Modifications at Harlequin 128k, issue 1

The following modifications relate to the issue 1 board of Harlequin 128k made by Don Dindang alias Superfo.

On the next page you see the cuts at the top (left picture) and bottom (right picture) side of U29.

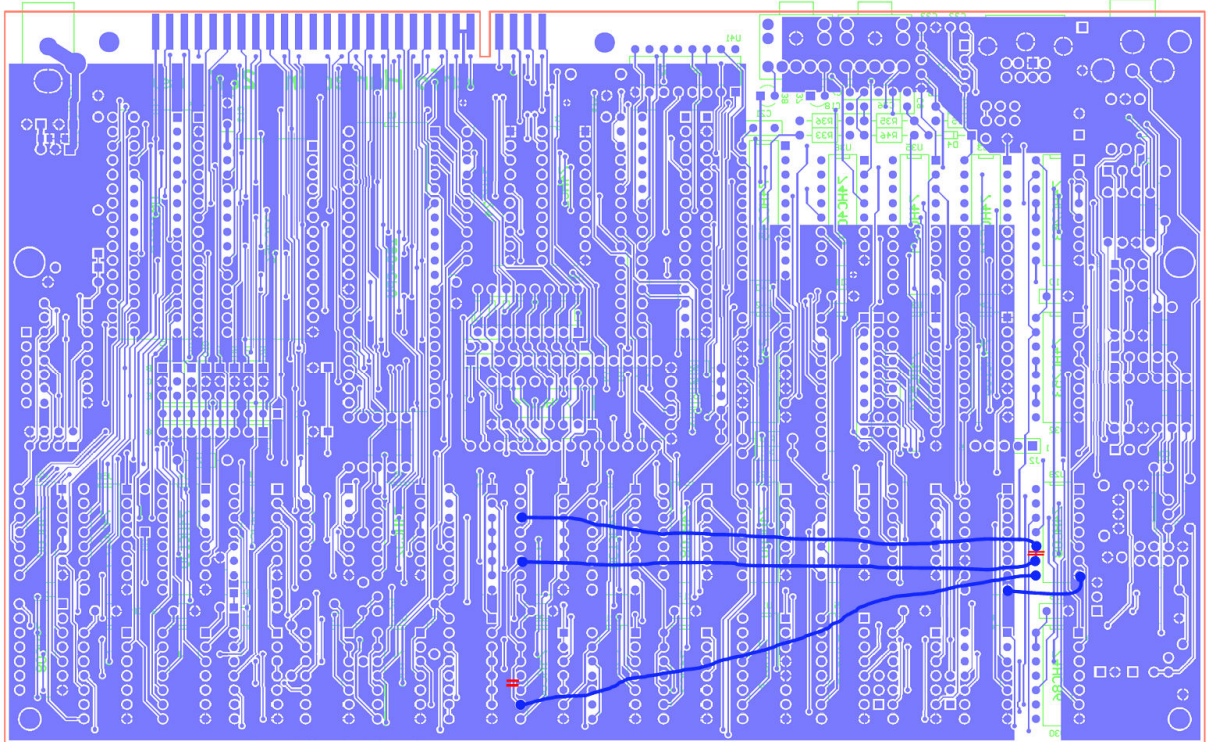
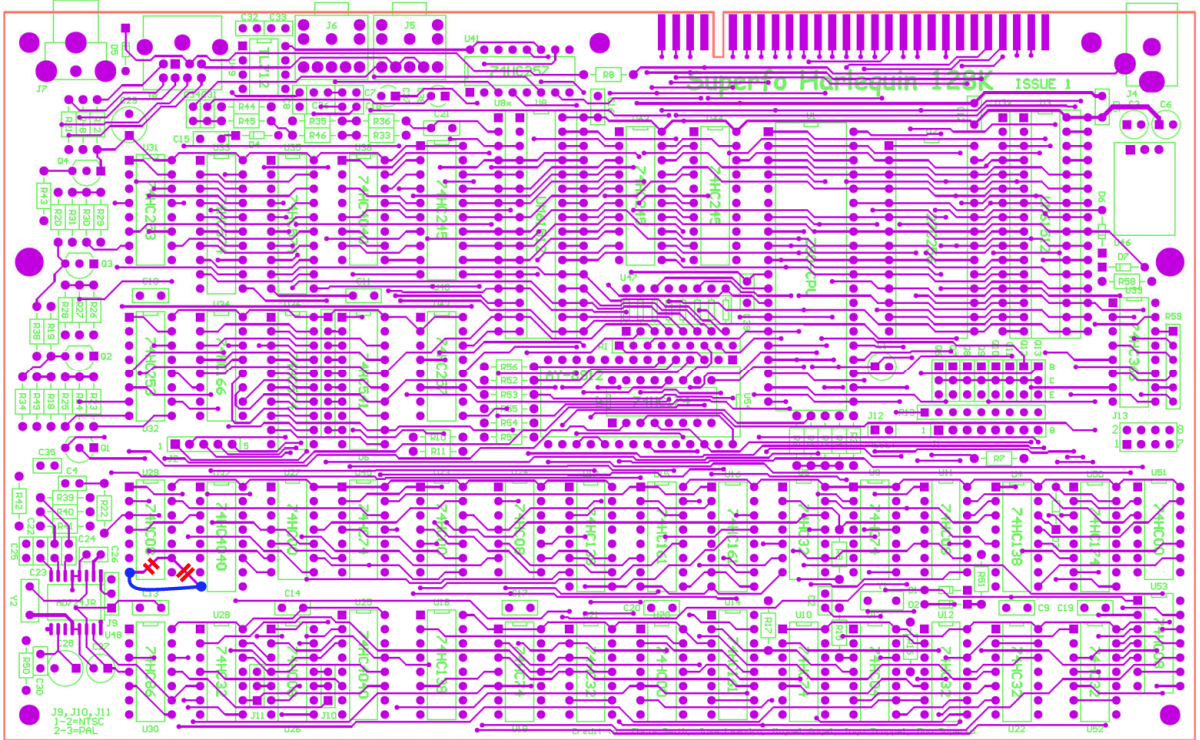
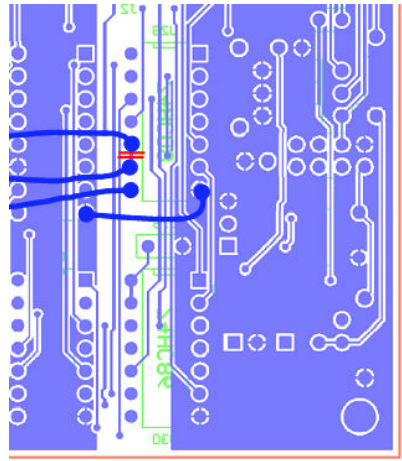
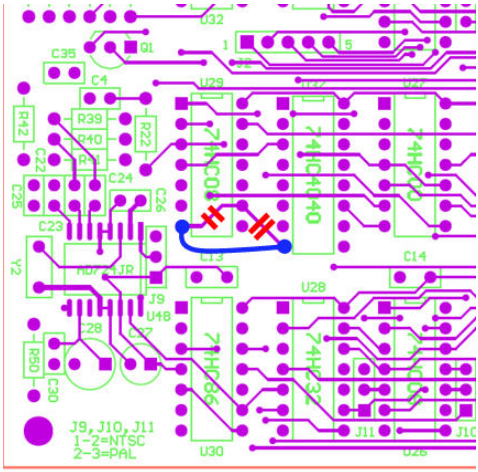
To realize 456 pixels per line, you have to cut two lines at the top side of the board, one is between pin 7 and pin 9 of U29, the other one connects pin 9 of U29 with pin 8 of U32. After that you have to cut the connection of pins 9 and 10 at the bottom side of the board. Next you should cut at the bottom side the connection between pin 12 and pin 9 of U20.

Now you have to reconnect pin 7 of U29 with pin 8 of U32 using a wire that is not too thin (ground line) – maybe on both sides of the board. Then there are 3 wires to solder: Connect pin 9 of U20 with pin 8 of U29. Connect pin 11 of U15 with pin 9 of U29 and connect pin 14 of U15 with pin 10 of U29.

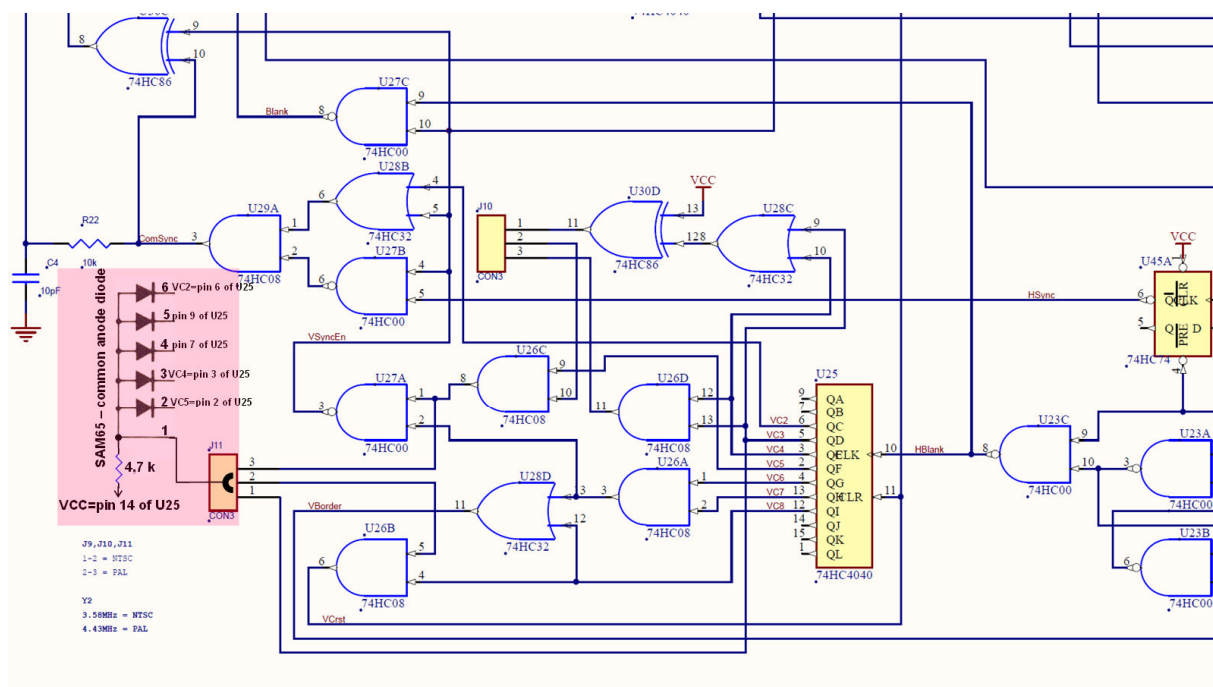
Now you have 456 pixels per line but 312 lines per frame as in 48k Spectrum. To correct this to 311 lines the simplest way is to solder 5 single diodes or a 5 diodes array with common anode as I did. I used the (old) GDR type SAM-65 (<https://www-user.tu-chemnitz.de/~heha/basteln/Konsumg%C3%BCter/DDR-Halbleiter/sam42.gif>) that you can find at ebay or at some small distributors in the net as NOS parts.

I soldered this diode array onto U25. pins 2,3 and 6 of the diode array are soldered to pins 2,3 and 6 of U25. Pin 4 of the array goes to pin 9 of U25 and pin 5 of the array goes to pin 7 of U25. Pin 1 of the diode (common cathode) is soldered to a 4,7 kOhm resistor that is soldered with its second pin to pin 16 of U25. A thin wire from the common cathode of the diode array is soldered to a 1-pin-jack that is plugged onto the centre pin of J11. As mentioned you can use 5 diodes 1N4148 instead of the array that could also be placed on U25. This way you have not to mod the board for the 311 line change. And you can simply unplug the mentioned single pin jack from J11 and insert a jumper on J11 instead.

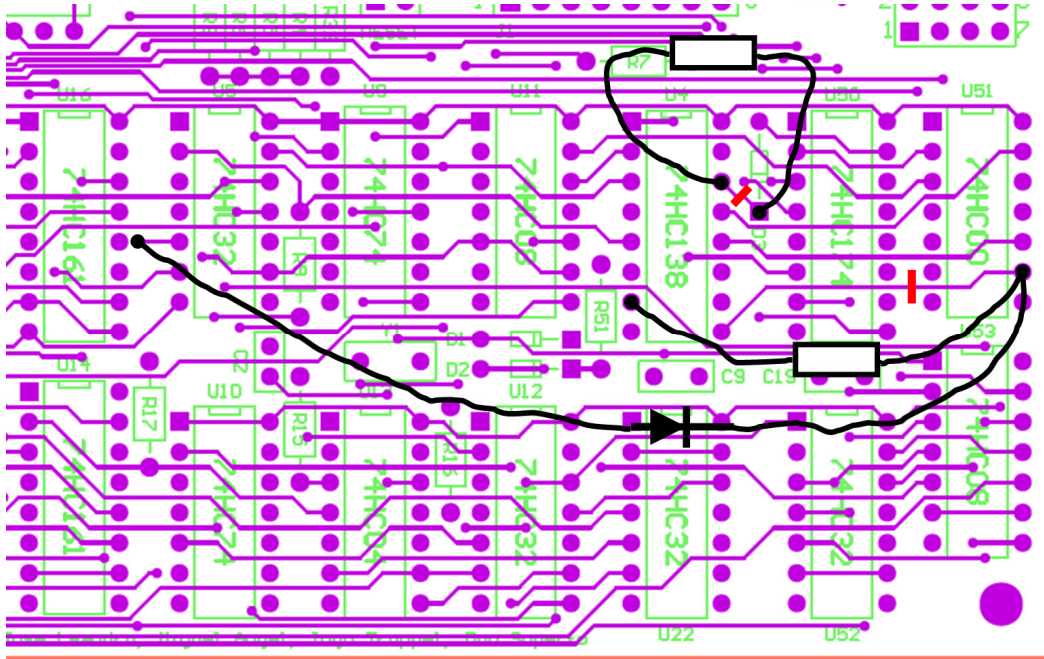
First, cut the very short connection near pin 14 of U4 at the top side (connection between pin 14 of U4 and cathode of D4). Insert here a resistor of 470 Ohm.

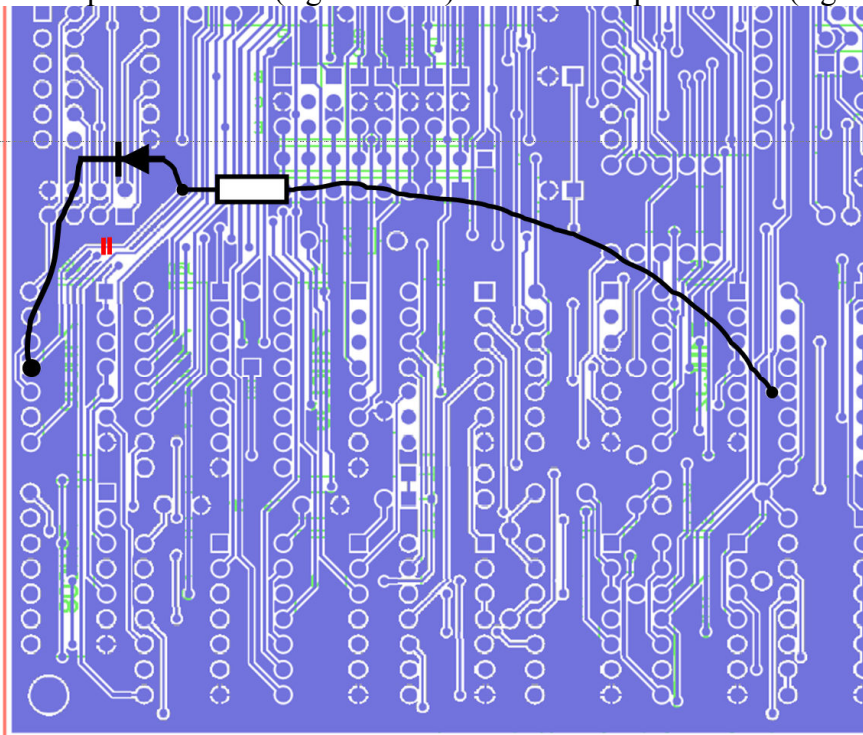
Then cut the connection between pin 9 of U4 and pin 9 of U51. Insert here also a 470 Ohm resistor and solder an additional diode 1N4148 from pin 9 of U51 (cathode) to pin 5 of U5 (anode) – signal /RD.

At the bottom side cut the connection that comes from pin 11 of U51. Insert a resistor of 470 in series to that line and insert a diode 1N4148 – cathode at the side of the new resistor that is not on pin 11 of U51 (signal BDIR) and anode at pin 5 of U5 (signal /RD).

7. improving the sound output:

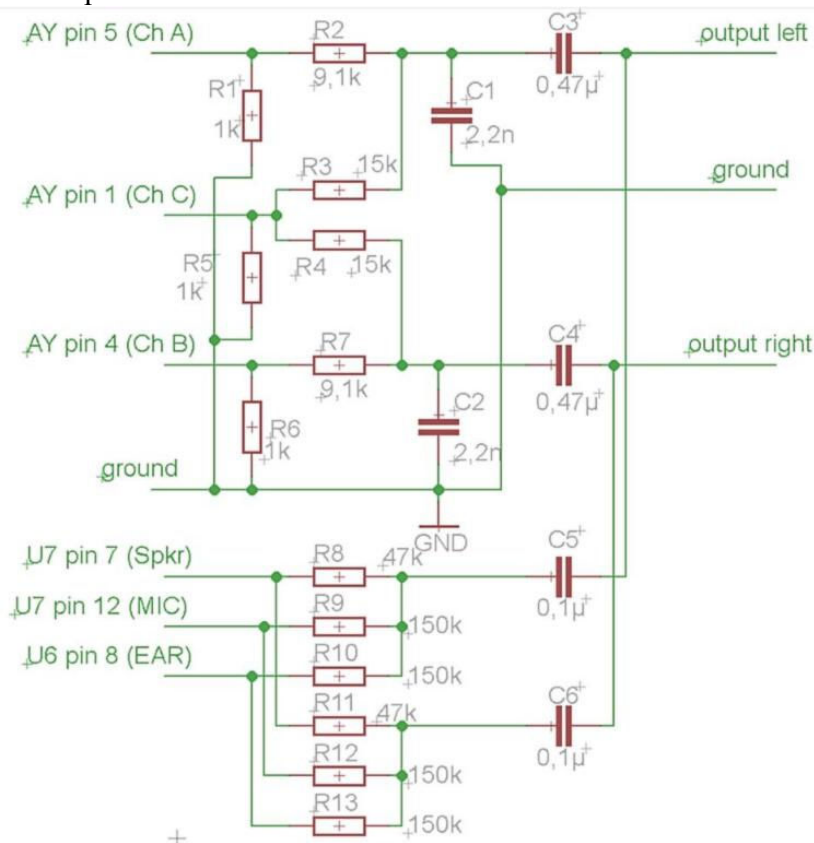
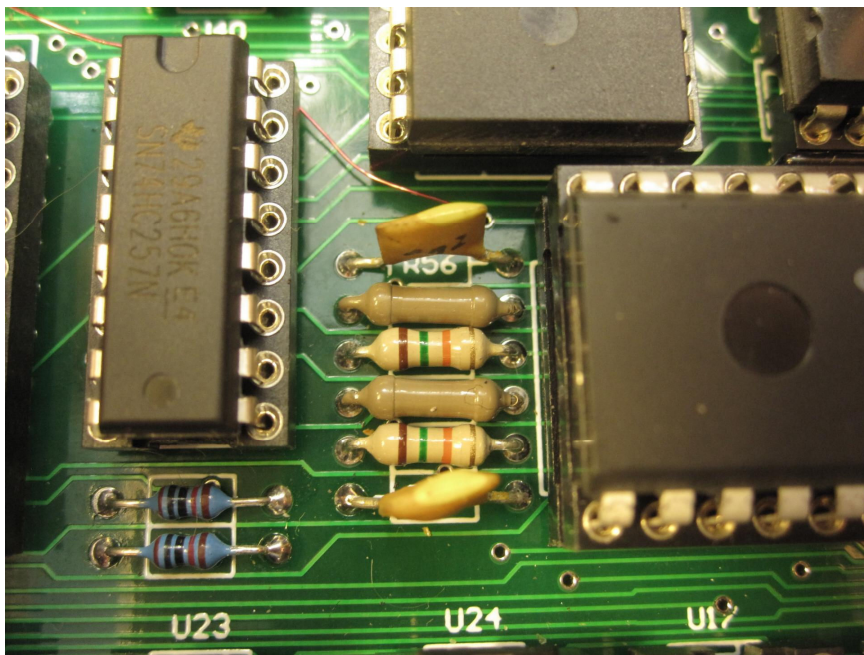
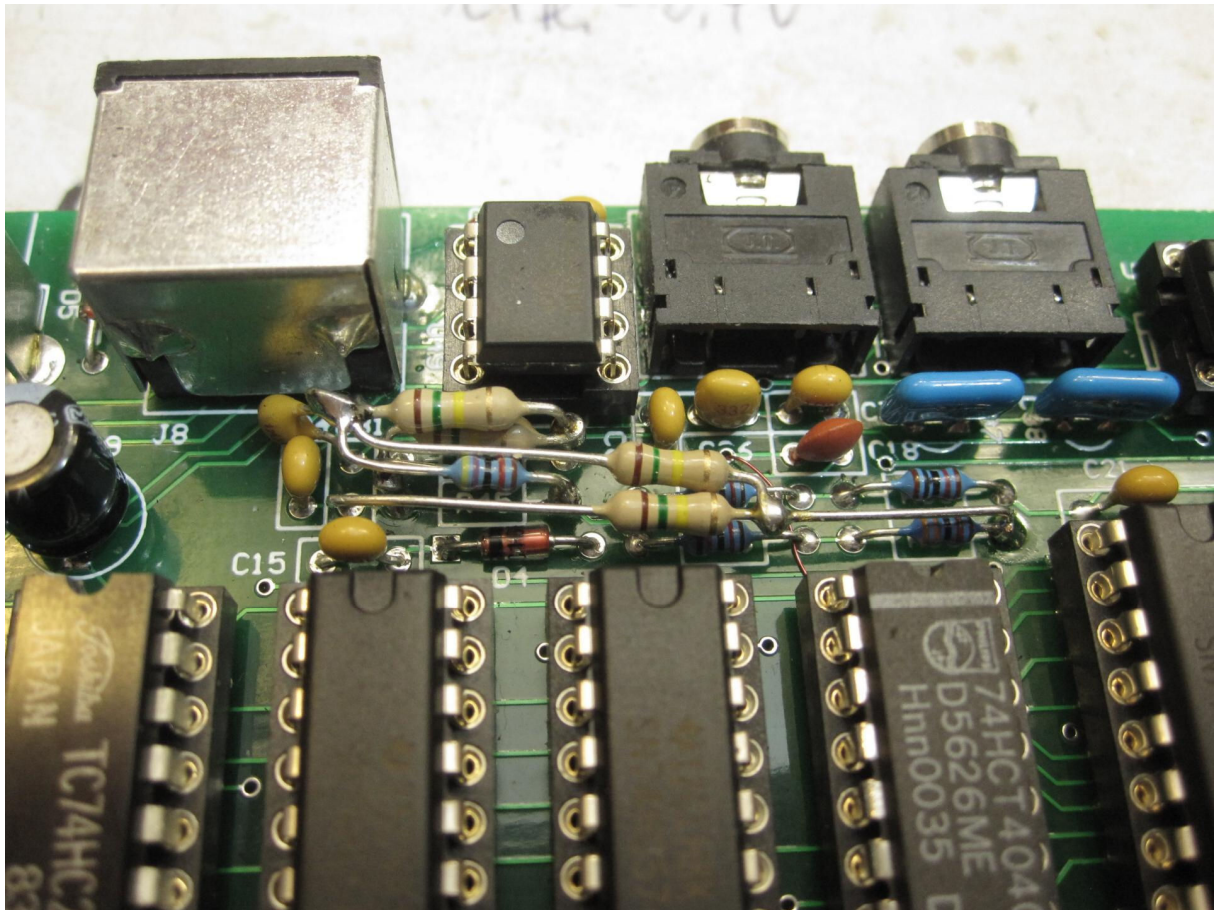
Instead of R56 and R57 solder $2,2\text{ nF}$ capacitors. R52 and R55 change to be $9,1\text{ k}\Omega$ and for R53 and R54 use $15\text{ k}\Omega$.

From pin 1, 4 and 5 of U54 (AY3-8912) there have to be $1\text{ k}\Omega$ resistors to ground (I used SMD types at the bottom side of the board).

C37, C38 should be $0,47\text{ }\mu\text{F}$ ceramic capacitors

C31, C34, R46, R45 have to be removed or not be soldered. Instead the schematic shown on the following page should be realized (only resistors and capacitors). Note that the numbers of the capacitors and resistors in that schematic do not refer to the numbering in the schematic of the harlequin 128k issue 1.
